Re: Response to Technical Deficiencies
MarkWest Liberty Midstream & Resources, L.L.C. – Harmon Creek Gas Plant
Application for Plan Approval PA-63-01011B
APS No. 1066962, AUTH No. 1471222
Smith Township, Washington County

MarkWest Liberty Midstream & Resources, L.L.C. (“**MPLX**”) is providing this response to the pre-denial and second technical deficiency letter received on November 12, 2024, to which the Department gave MPLX only 10 business days to respond. The majority of the Department’s requests were either previously addressed by MPLX and/or were items that were provided in the plan approval application and could have been requested in the initial technical deficiency letter. Nevertheless, MPLX has attempted to address all points raised in the Department’s letter. To that end, please find MPLX’s responses, including references to the application and previous correspondence for items that have already been supplied.

Attachment 6
Updated Process Flow Diagram

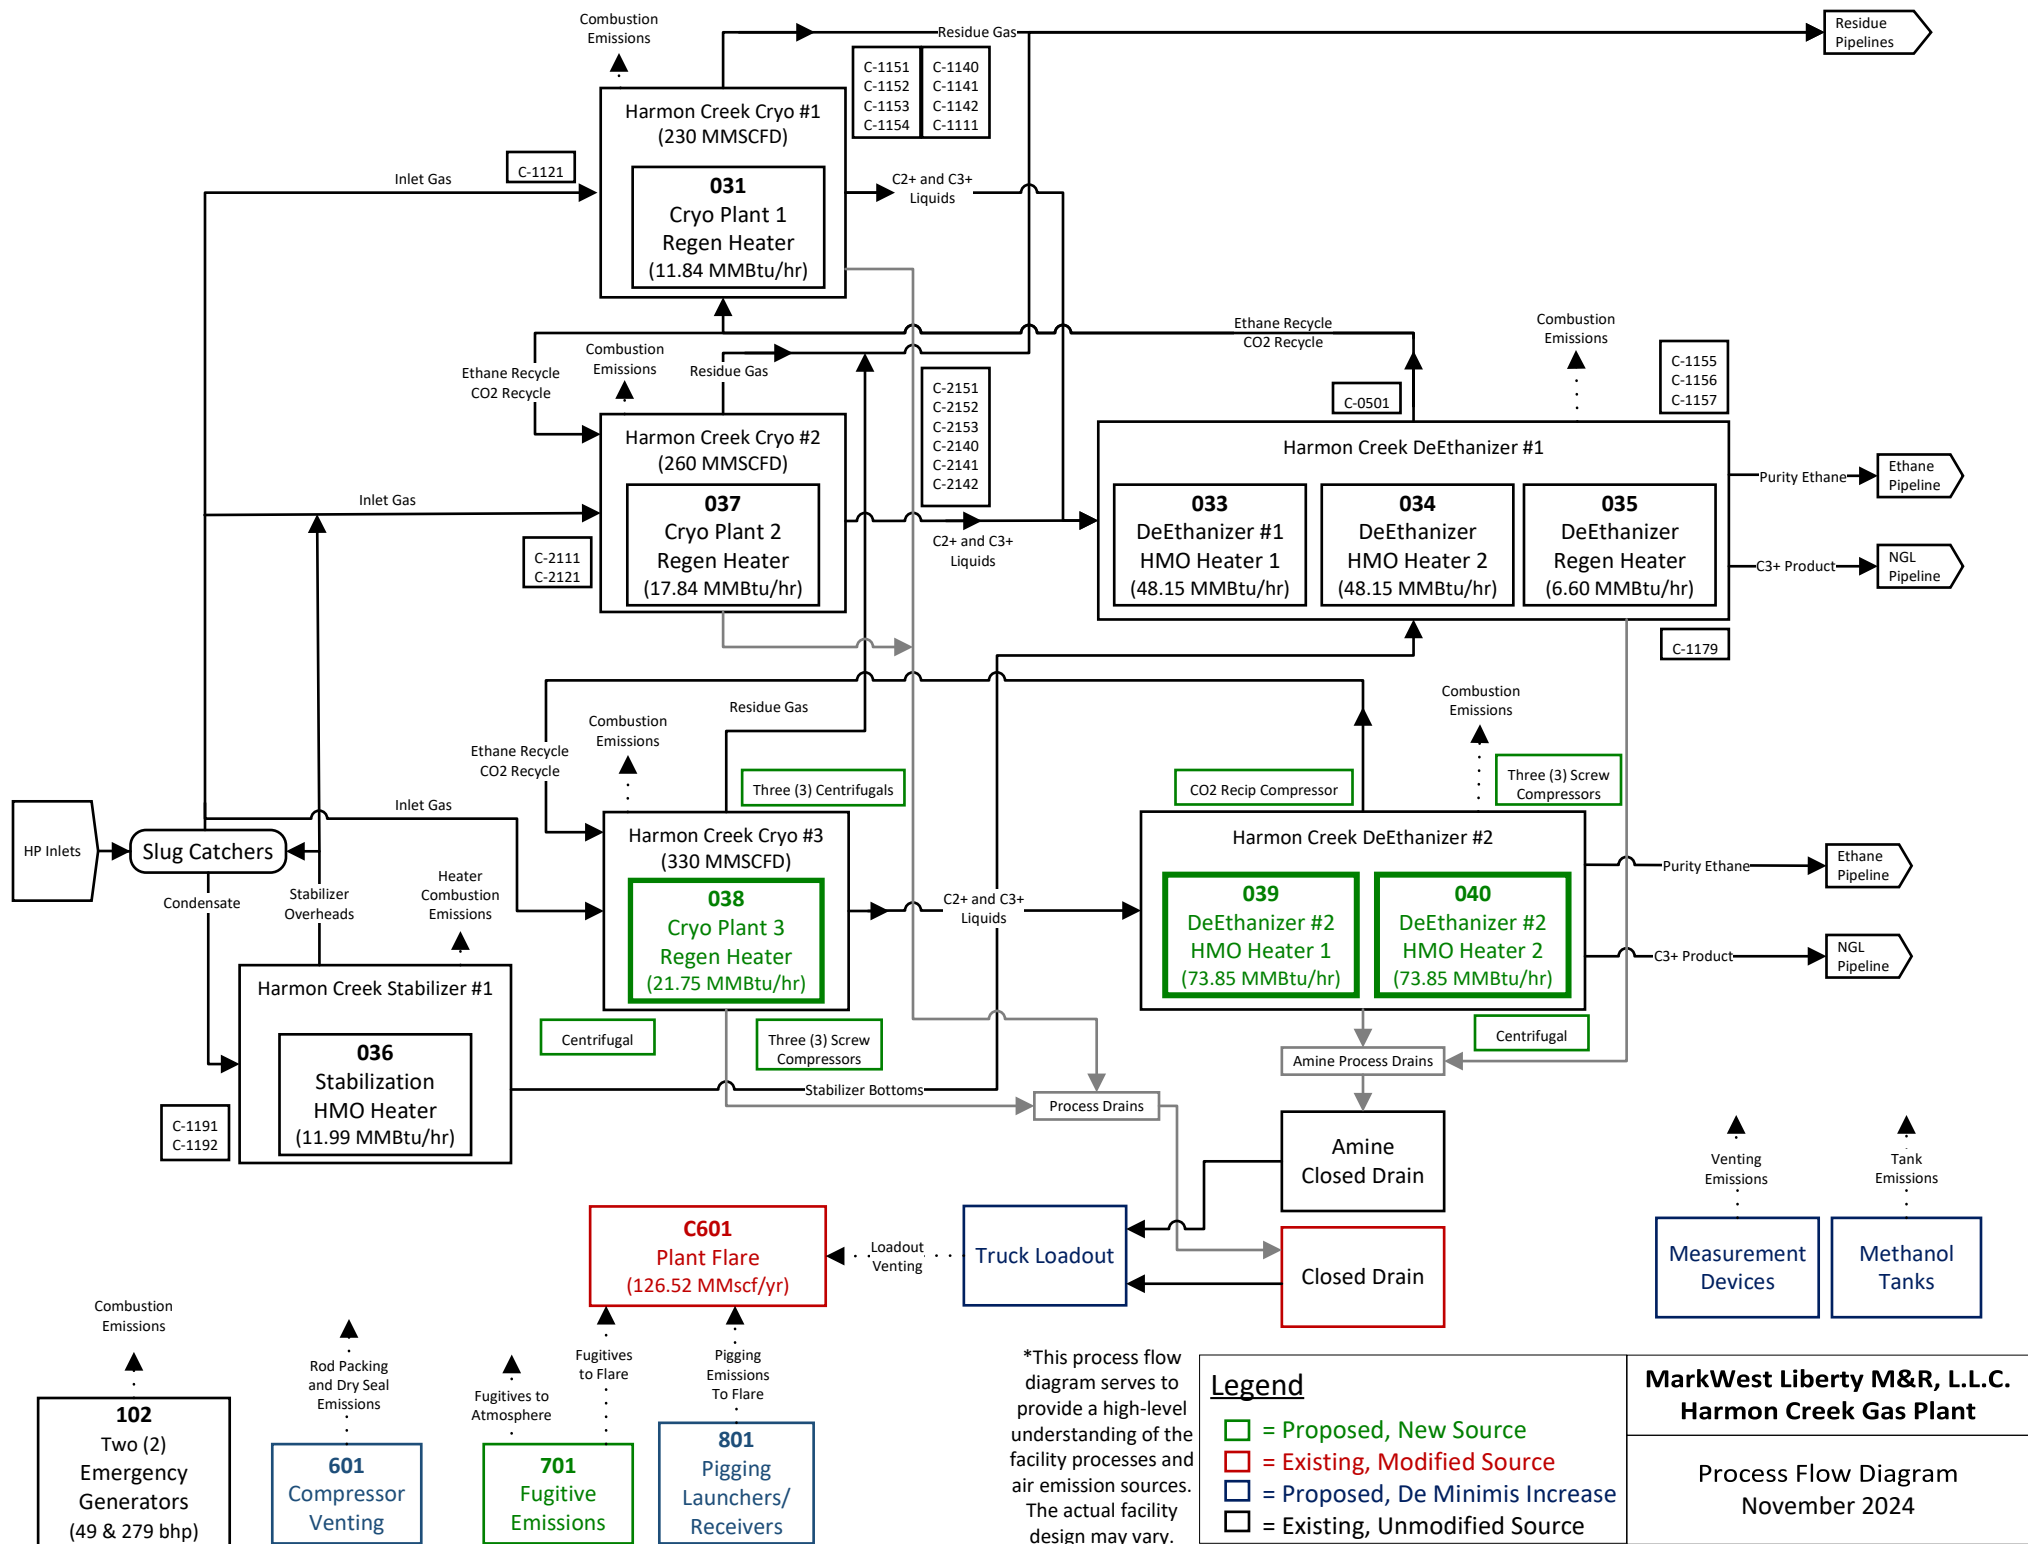
8. The PFD has been updated to include the compressors requested by the Department and can be found in Attachment 6 of this response. To simplify the PFD, information regarding the location in which blowdowns and venting are routed has been included separately. Please refer to the “Estimated Potential Blowdowns (Controlled by Flare)” list, in Attachment 4, which has been updated to indicate the plant location of each compressor and if maintenance blowdowns and compressor rod packing/dry seal venting are routed to the flare or atmosphere.
